HI-STAR ATB 1T

TYPE B(U) TRANSPORTATION PACKAGE

Proposed Responses to Second Request for Additional Information

August 24, 2018

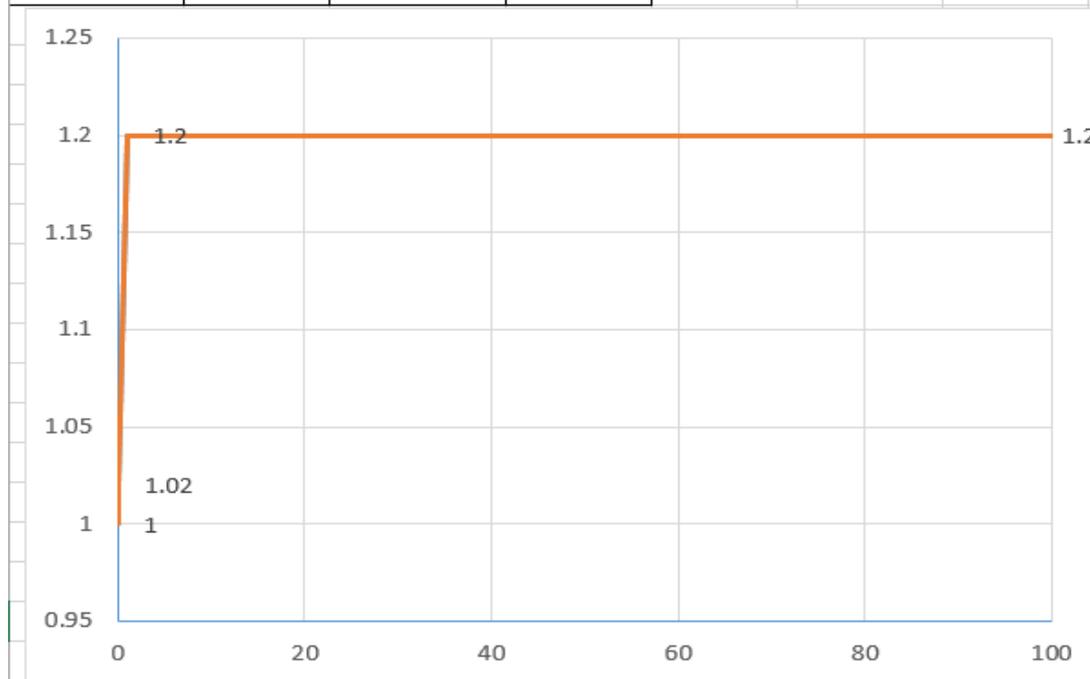
- Clarify the values used to model identical materials in the LS-DYNA drop simulation files. Justify use of two materials in the model representing Nitronic 50.

- Both MID 2 and 3 have the identical stress strain curves and triaxiality factors. The strain rate amplifier used for MID 2 is slightly over-estimated for the strain rates between 0 and 0.1 (as shown in figure below) resulting in slightly higher stress prediction at low strain rates. However, the strain rates for ATB-1T cask components, subject to 10CFR71 drops, are as high as 100 in/in/sec. Therefore, the cask response and the corresponding results are unaffected by this minor discrepancy. However, this inconsistency in the material models will be corrected.

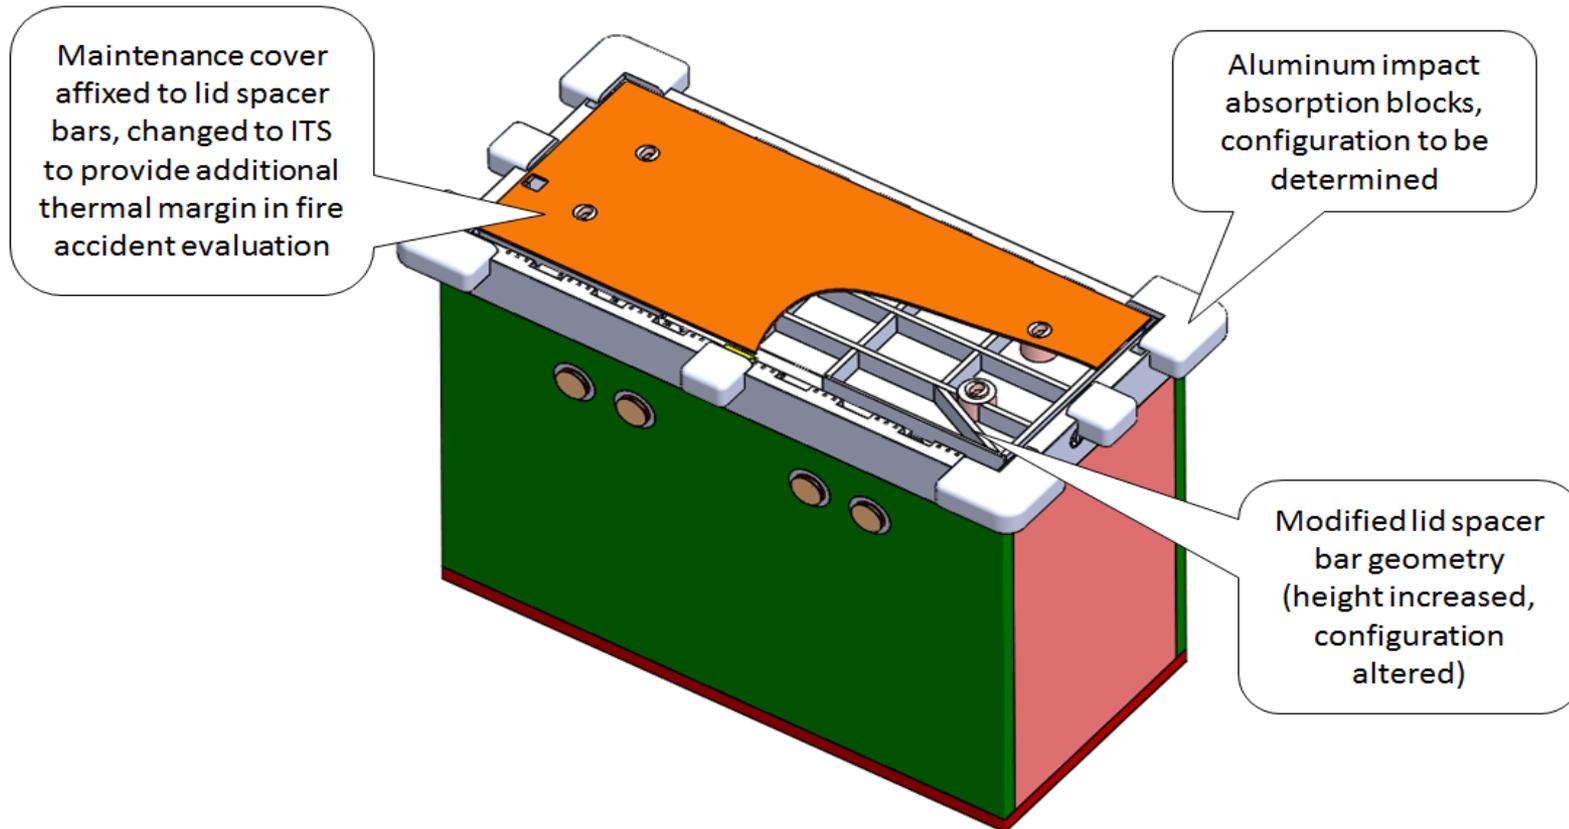
- Provide evidence that demonstrates the package will meet regulatory release limits during normal conditions and hypothetical accident conditions (plastic deformation at seal and closure region during NCT and HAC).

- Holtec has considered few design and analytical modifications to eliminate the inelastic strain in the sealing surfaces. The key changes are summarized below:
 - Add high strength Incoloy cladding on the seal seating surface on the top flange and the closure lid.
 - Add softer crush material such as Al 6061 on the top corners of the closure flange extending beyond the cask top flange (see figure on next page).
 - The crush material will be connected to the existing top flange using weak links and will not interfere with the lid placement. Further details will be captured in the final licensing dwg.
 - Explicitly model the seal grooves and the seals to capture the behavior of the joint more accurately (see figures on following pages).

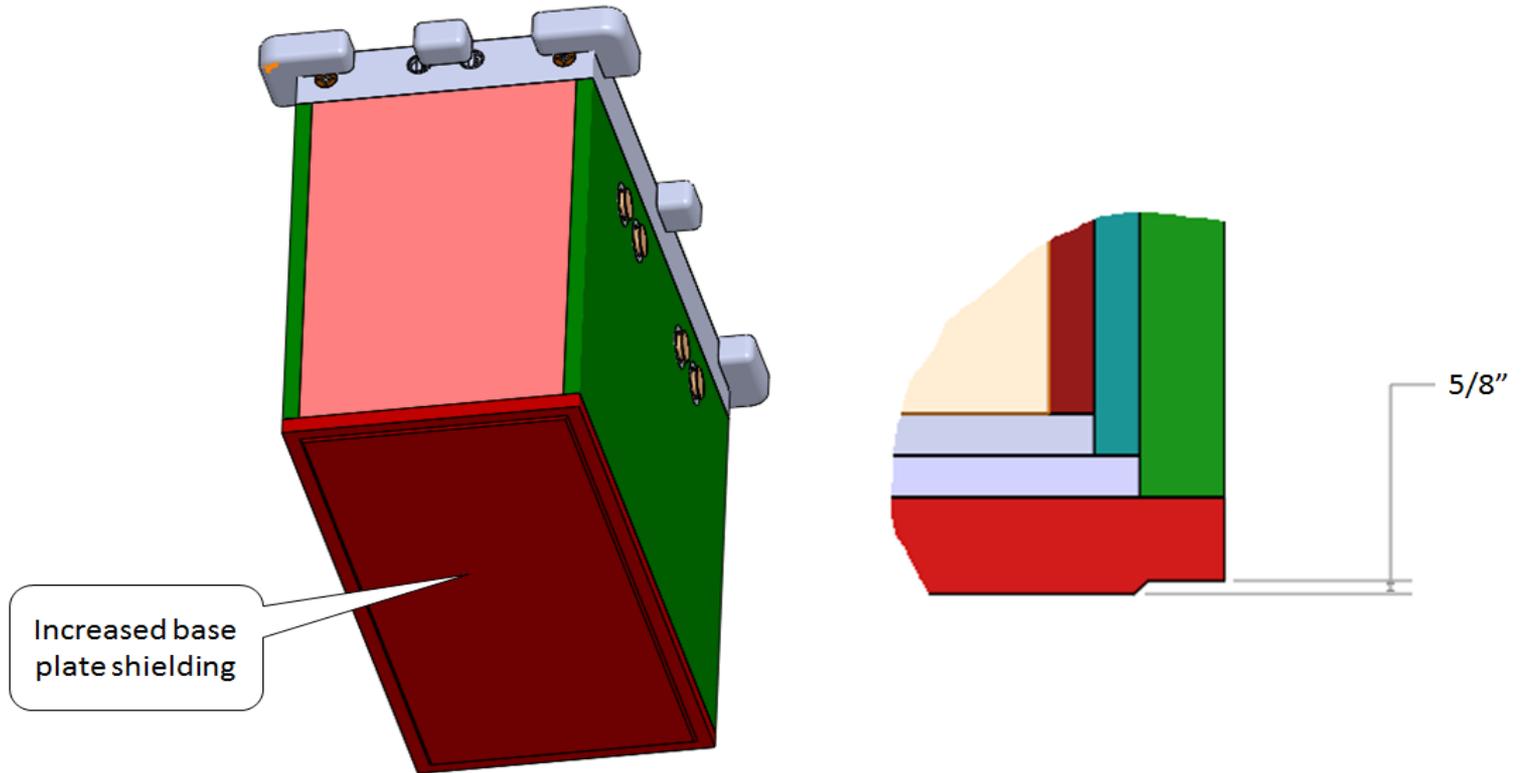
- Evaluate HAC dose rates using a bounding model of the bottom BTC (BFA-Tank Cassette) plate or restrict contents so that source cannot relocate outside the BTC plates.

- Model is modified and now assumes the Bottom BTC plate is replaced with waste. Additional steel is added to the bottom surface of the HI-STAR ATB 1T cask to ensure accident dose limits are met.
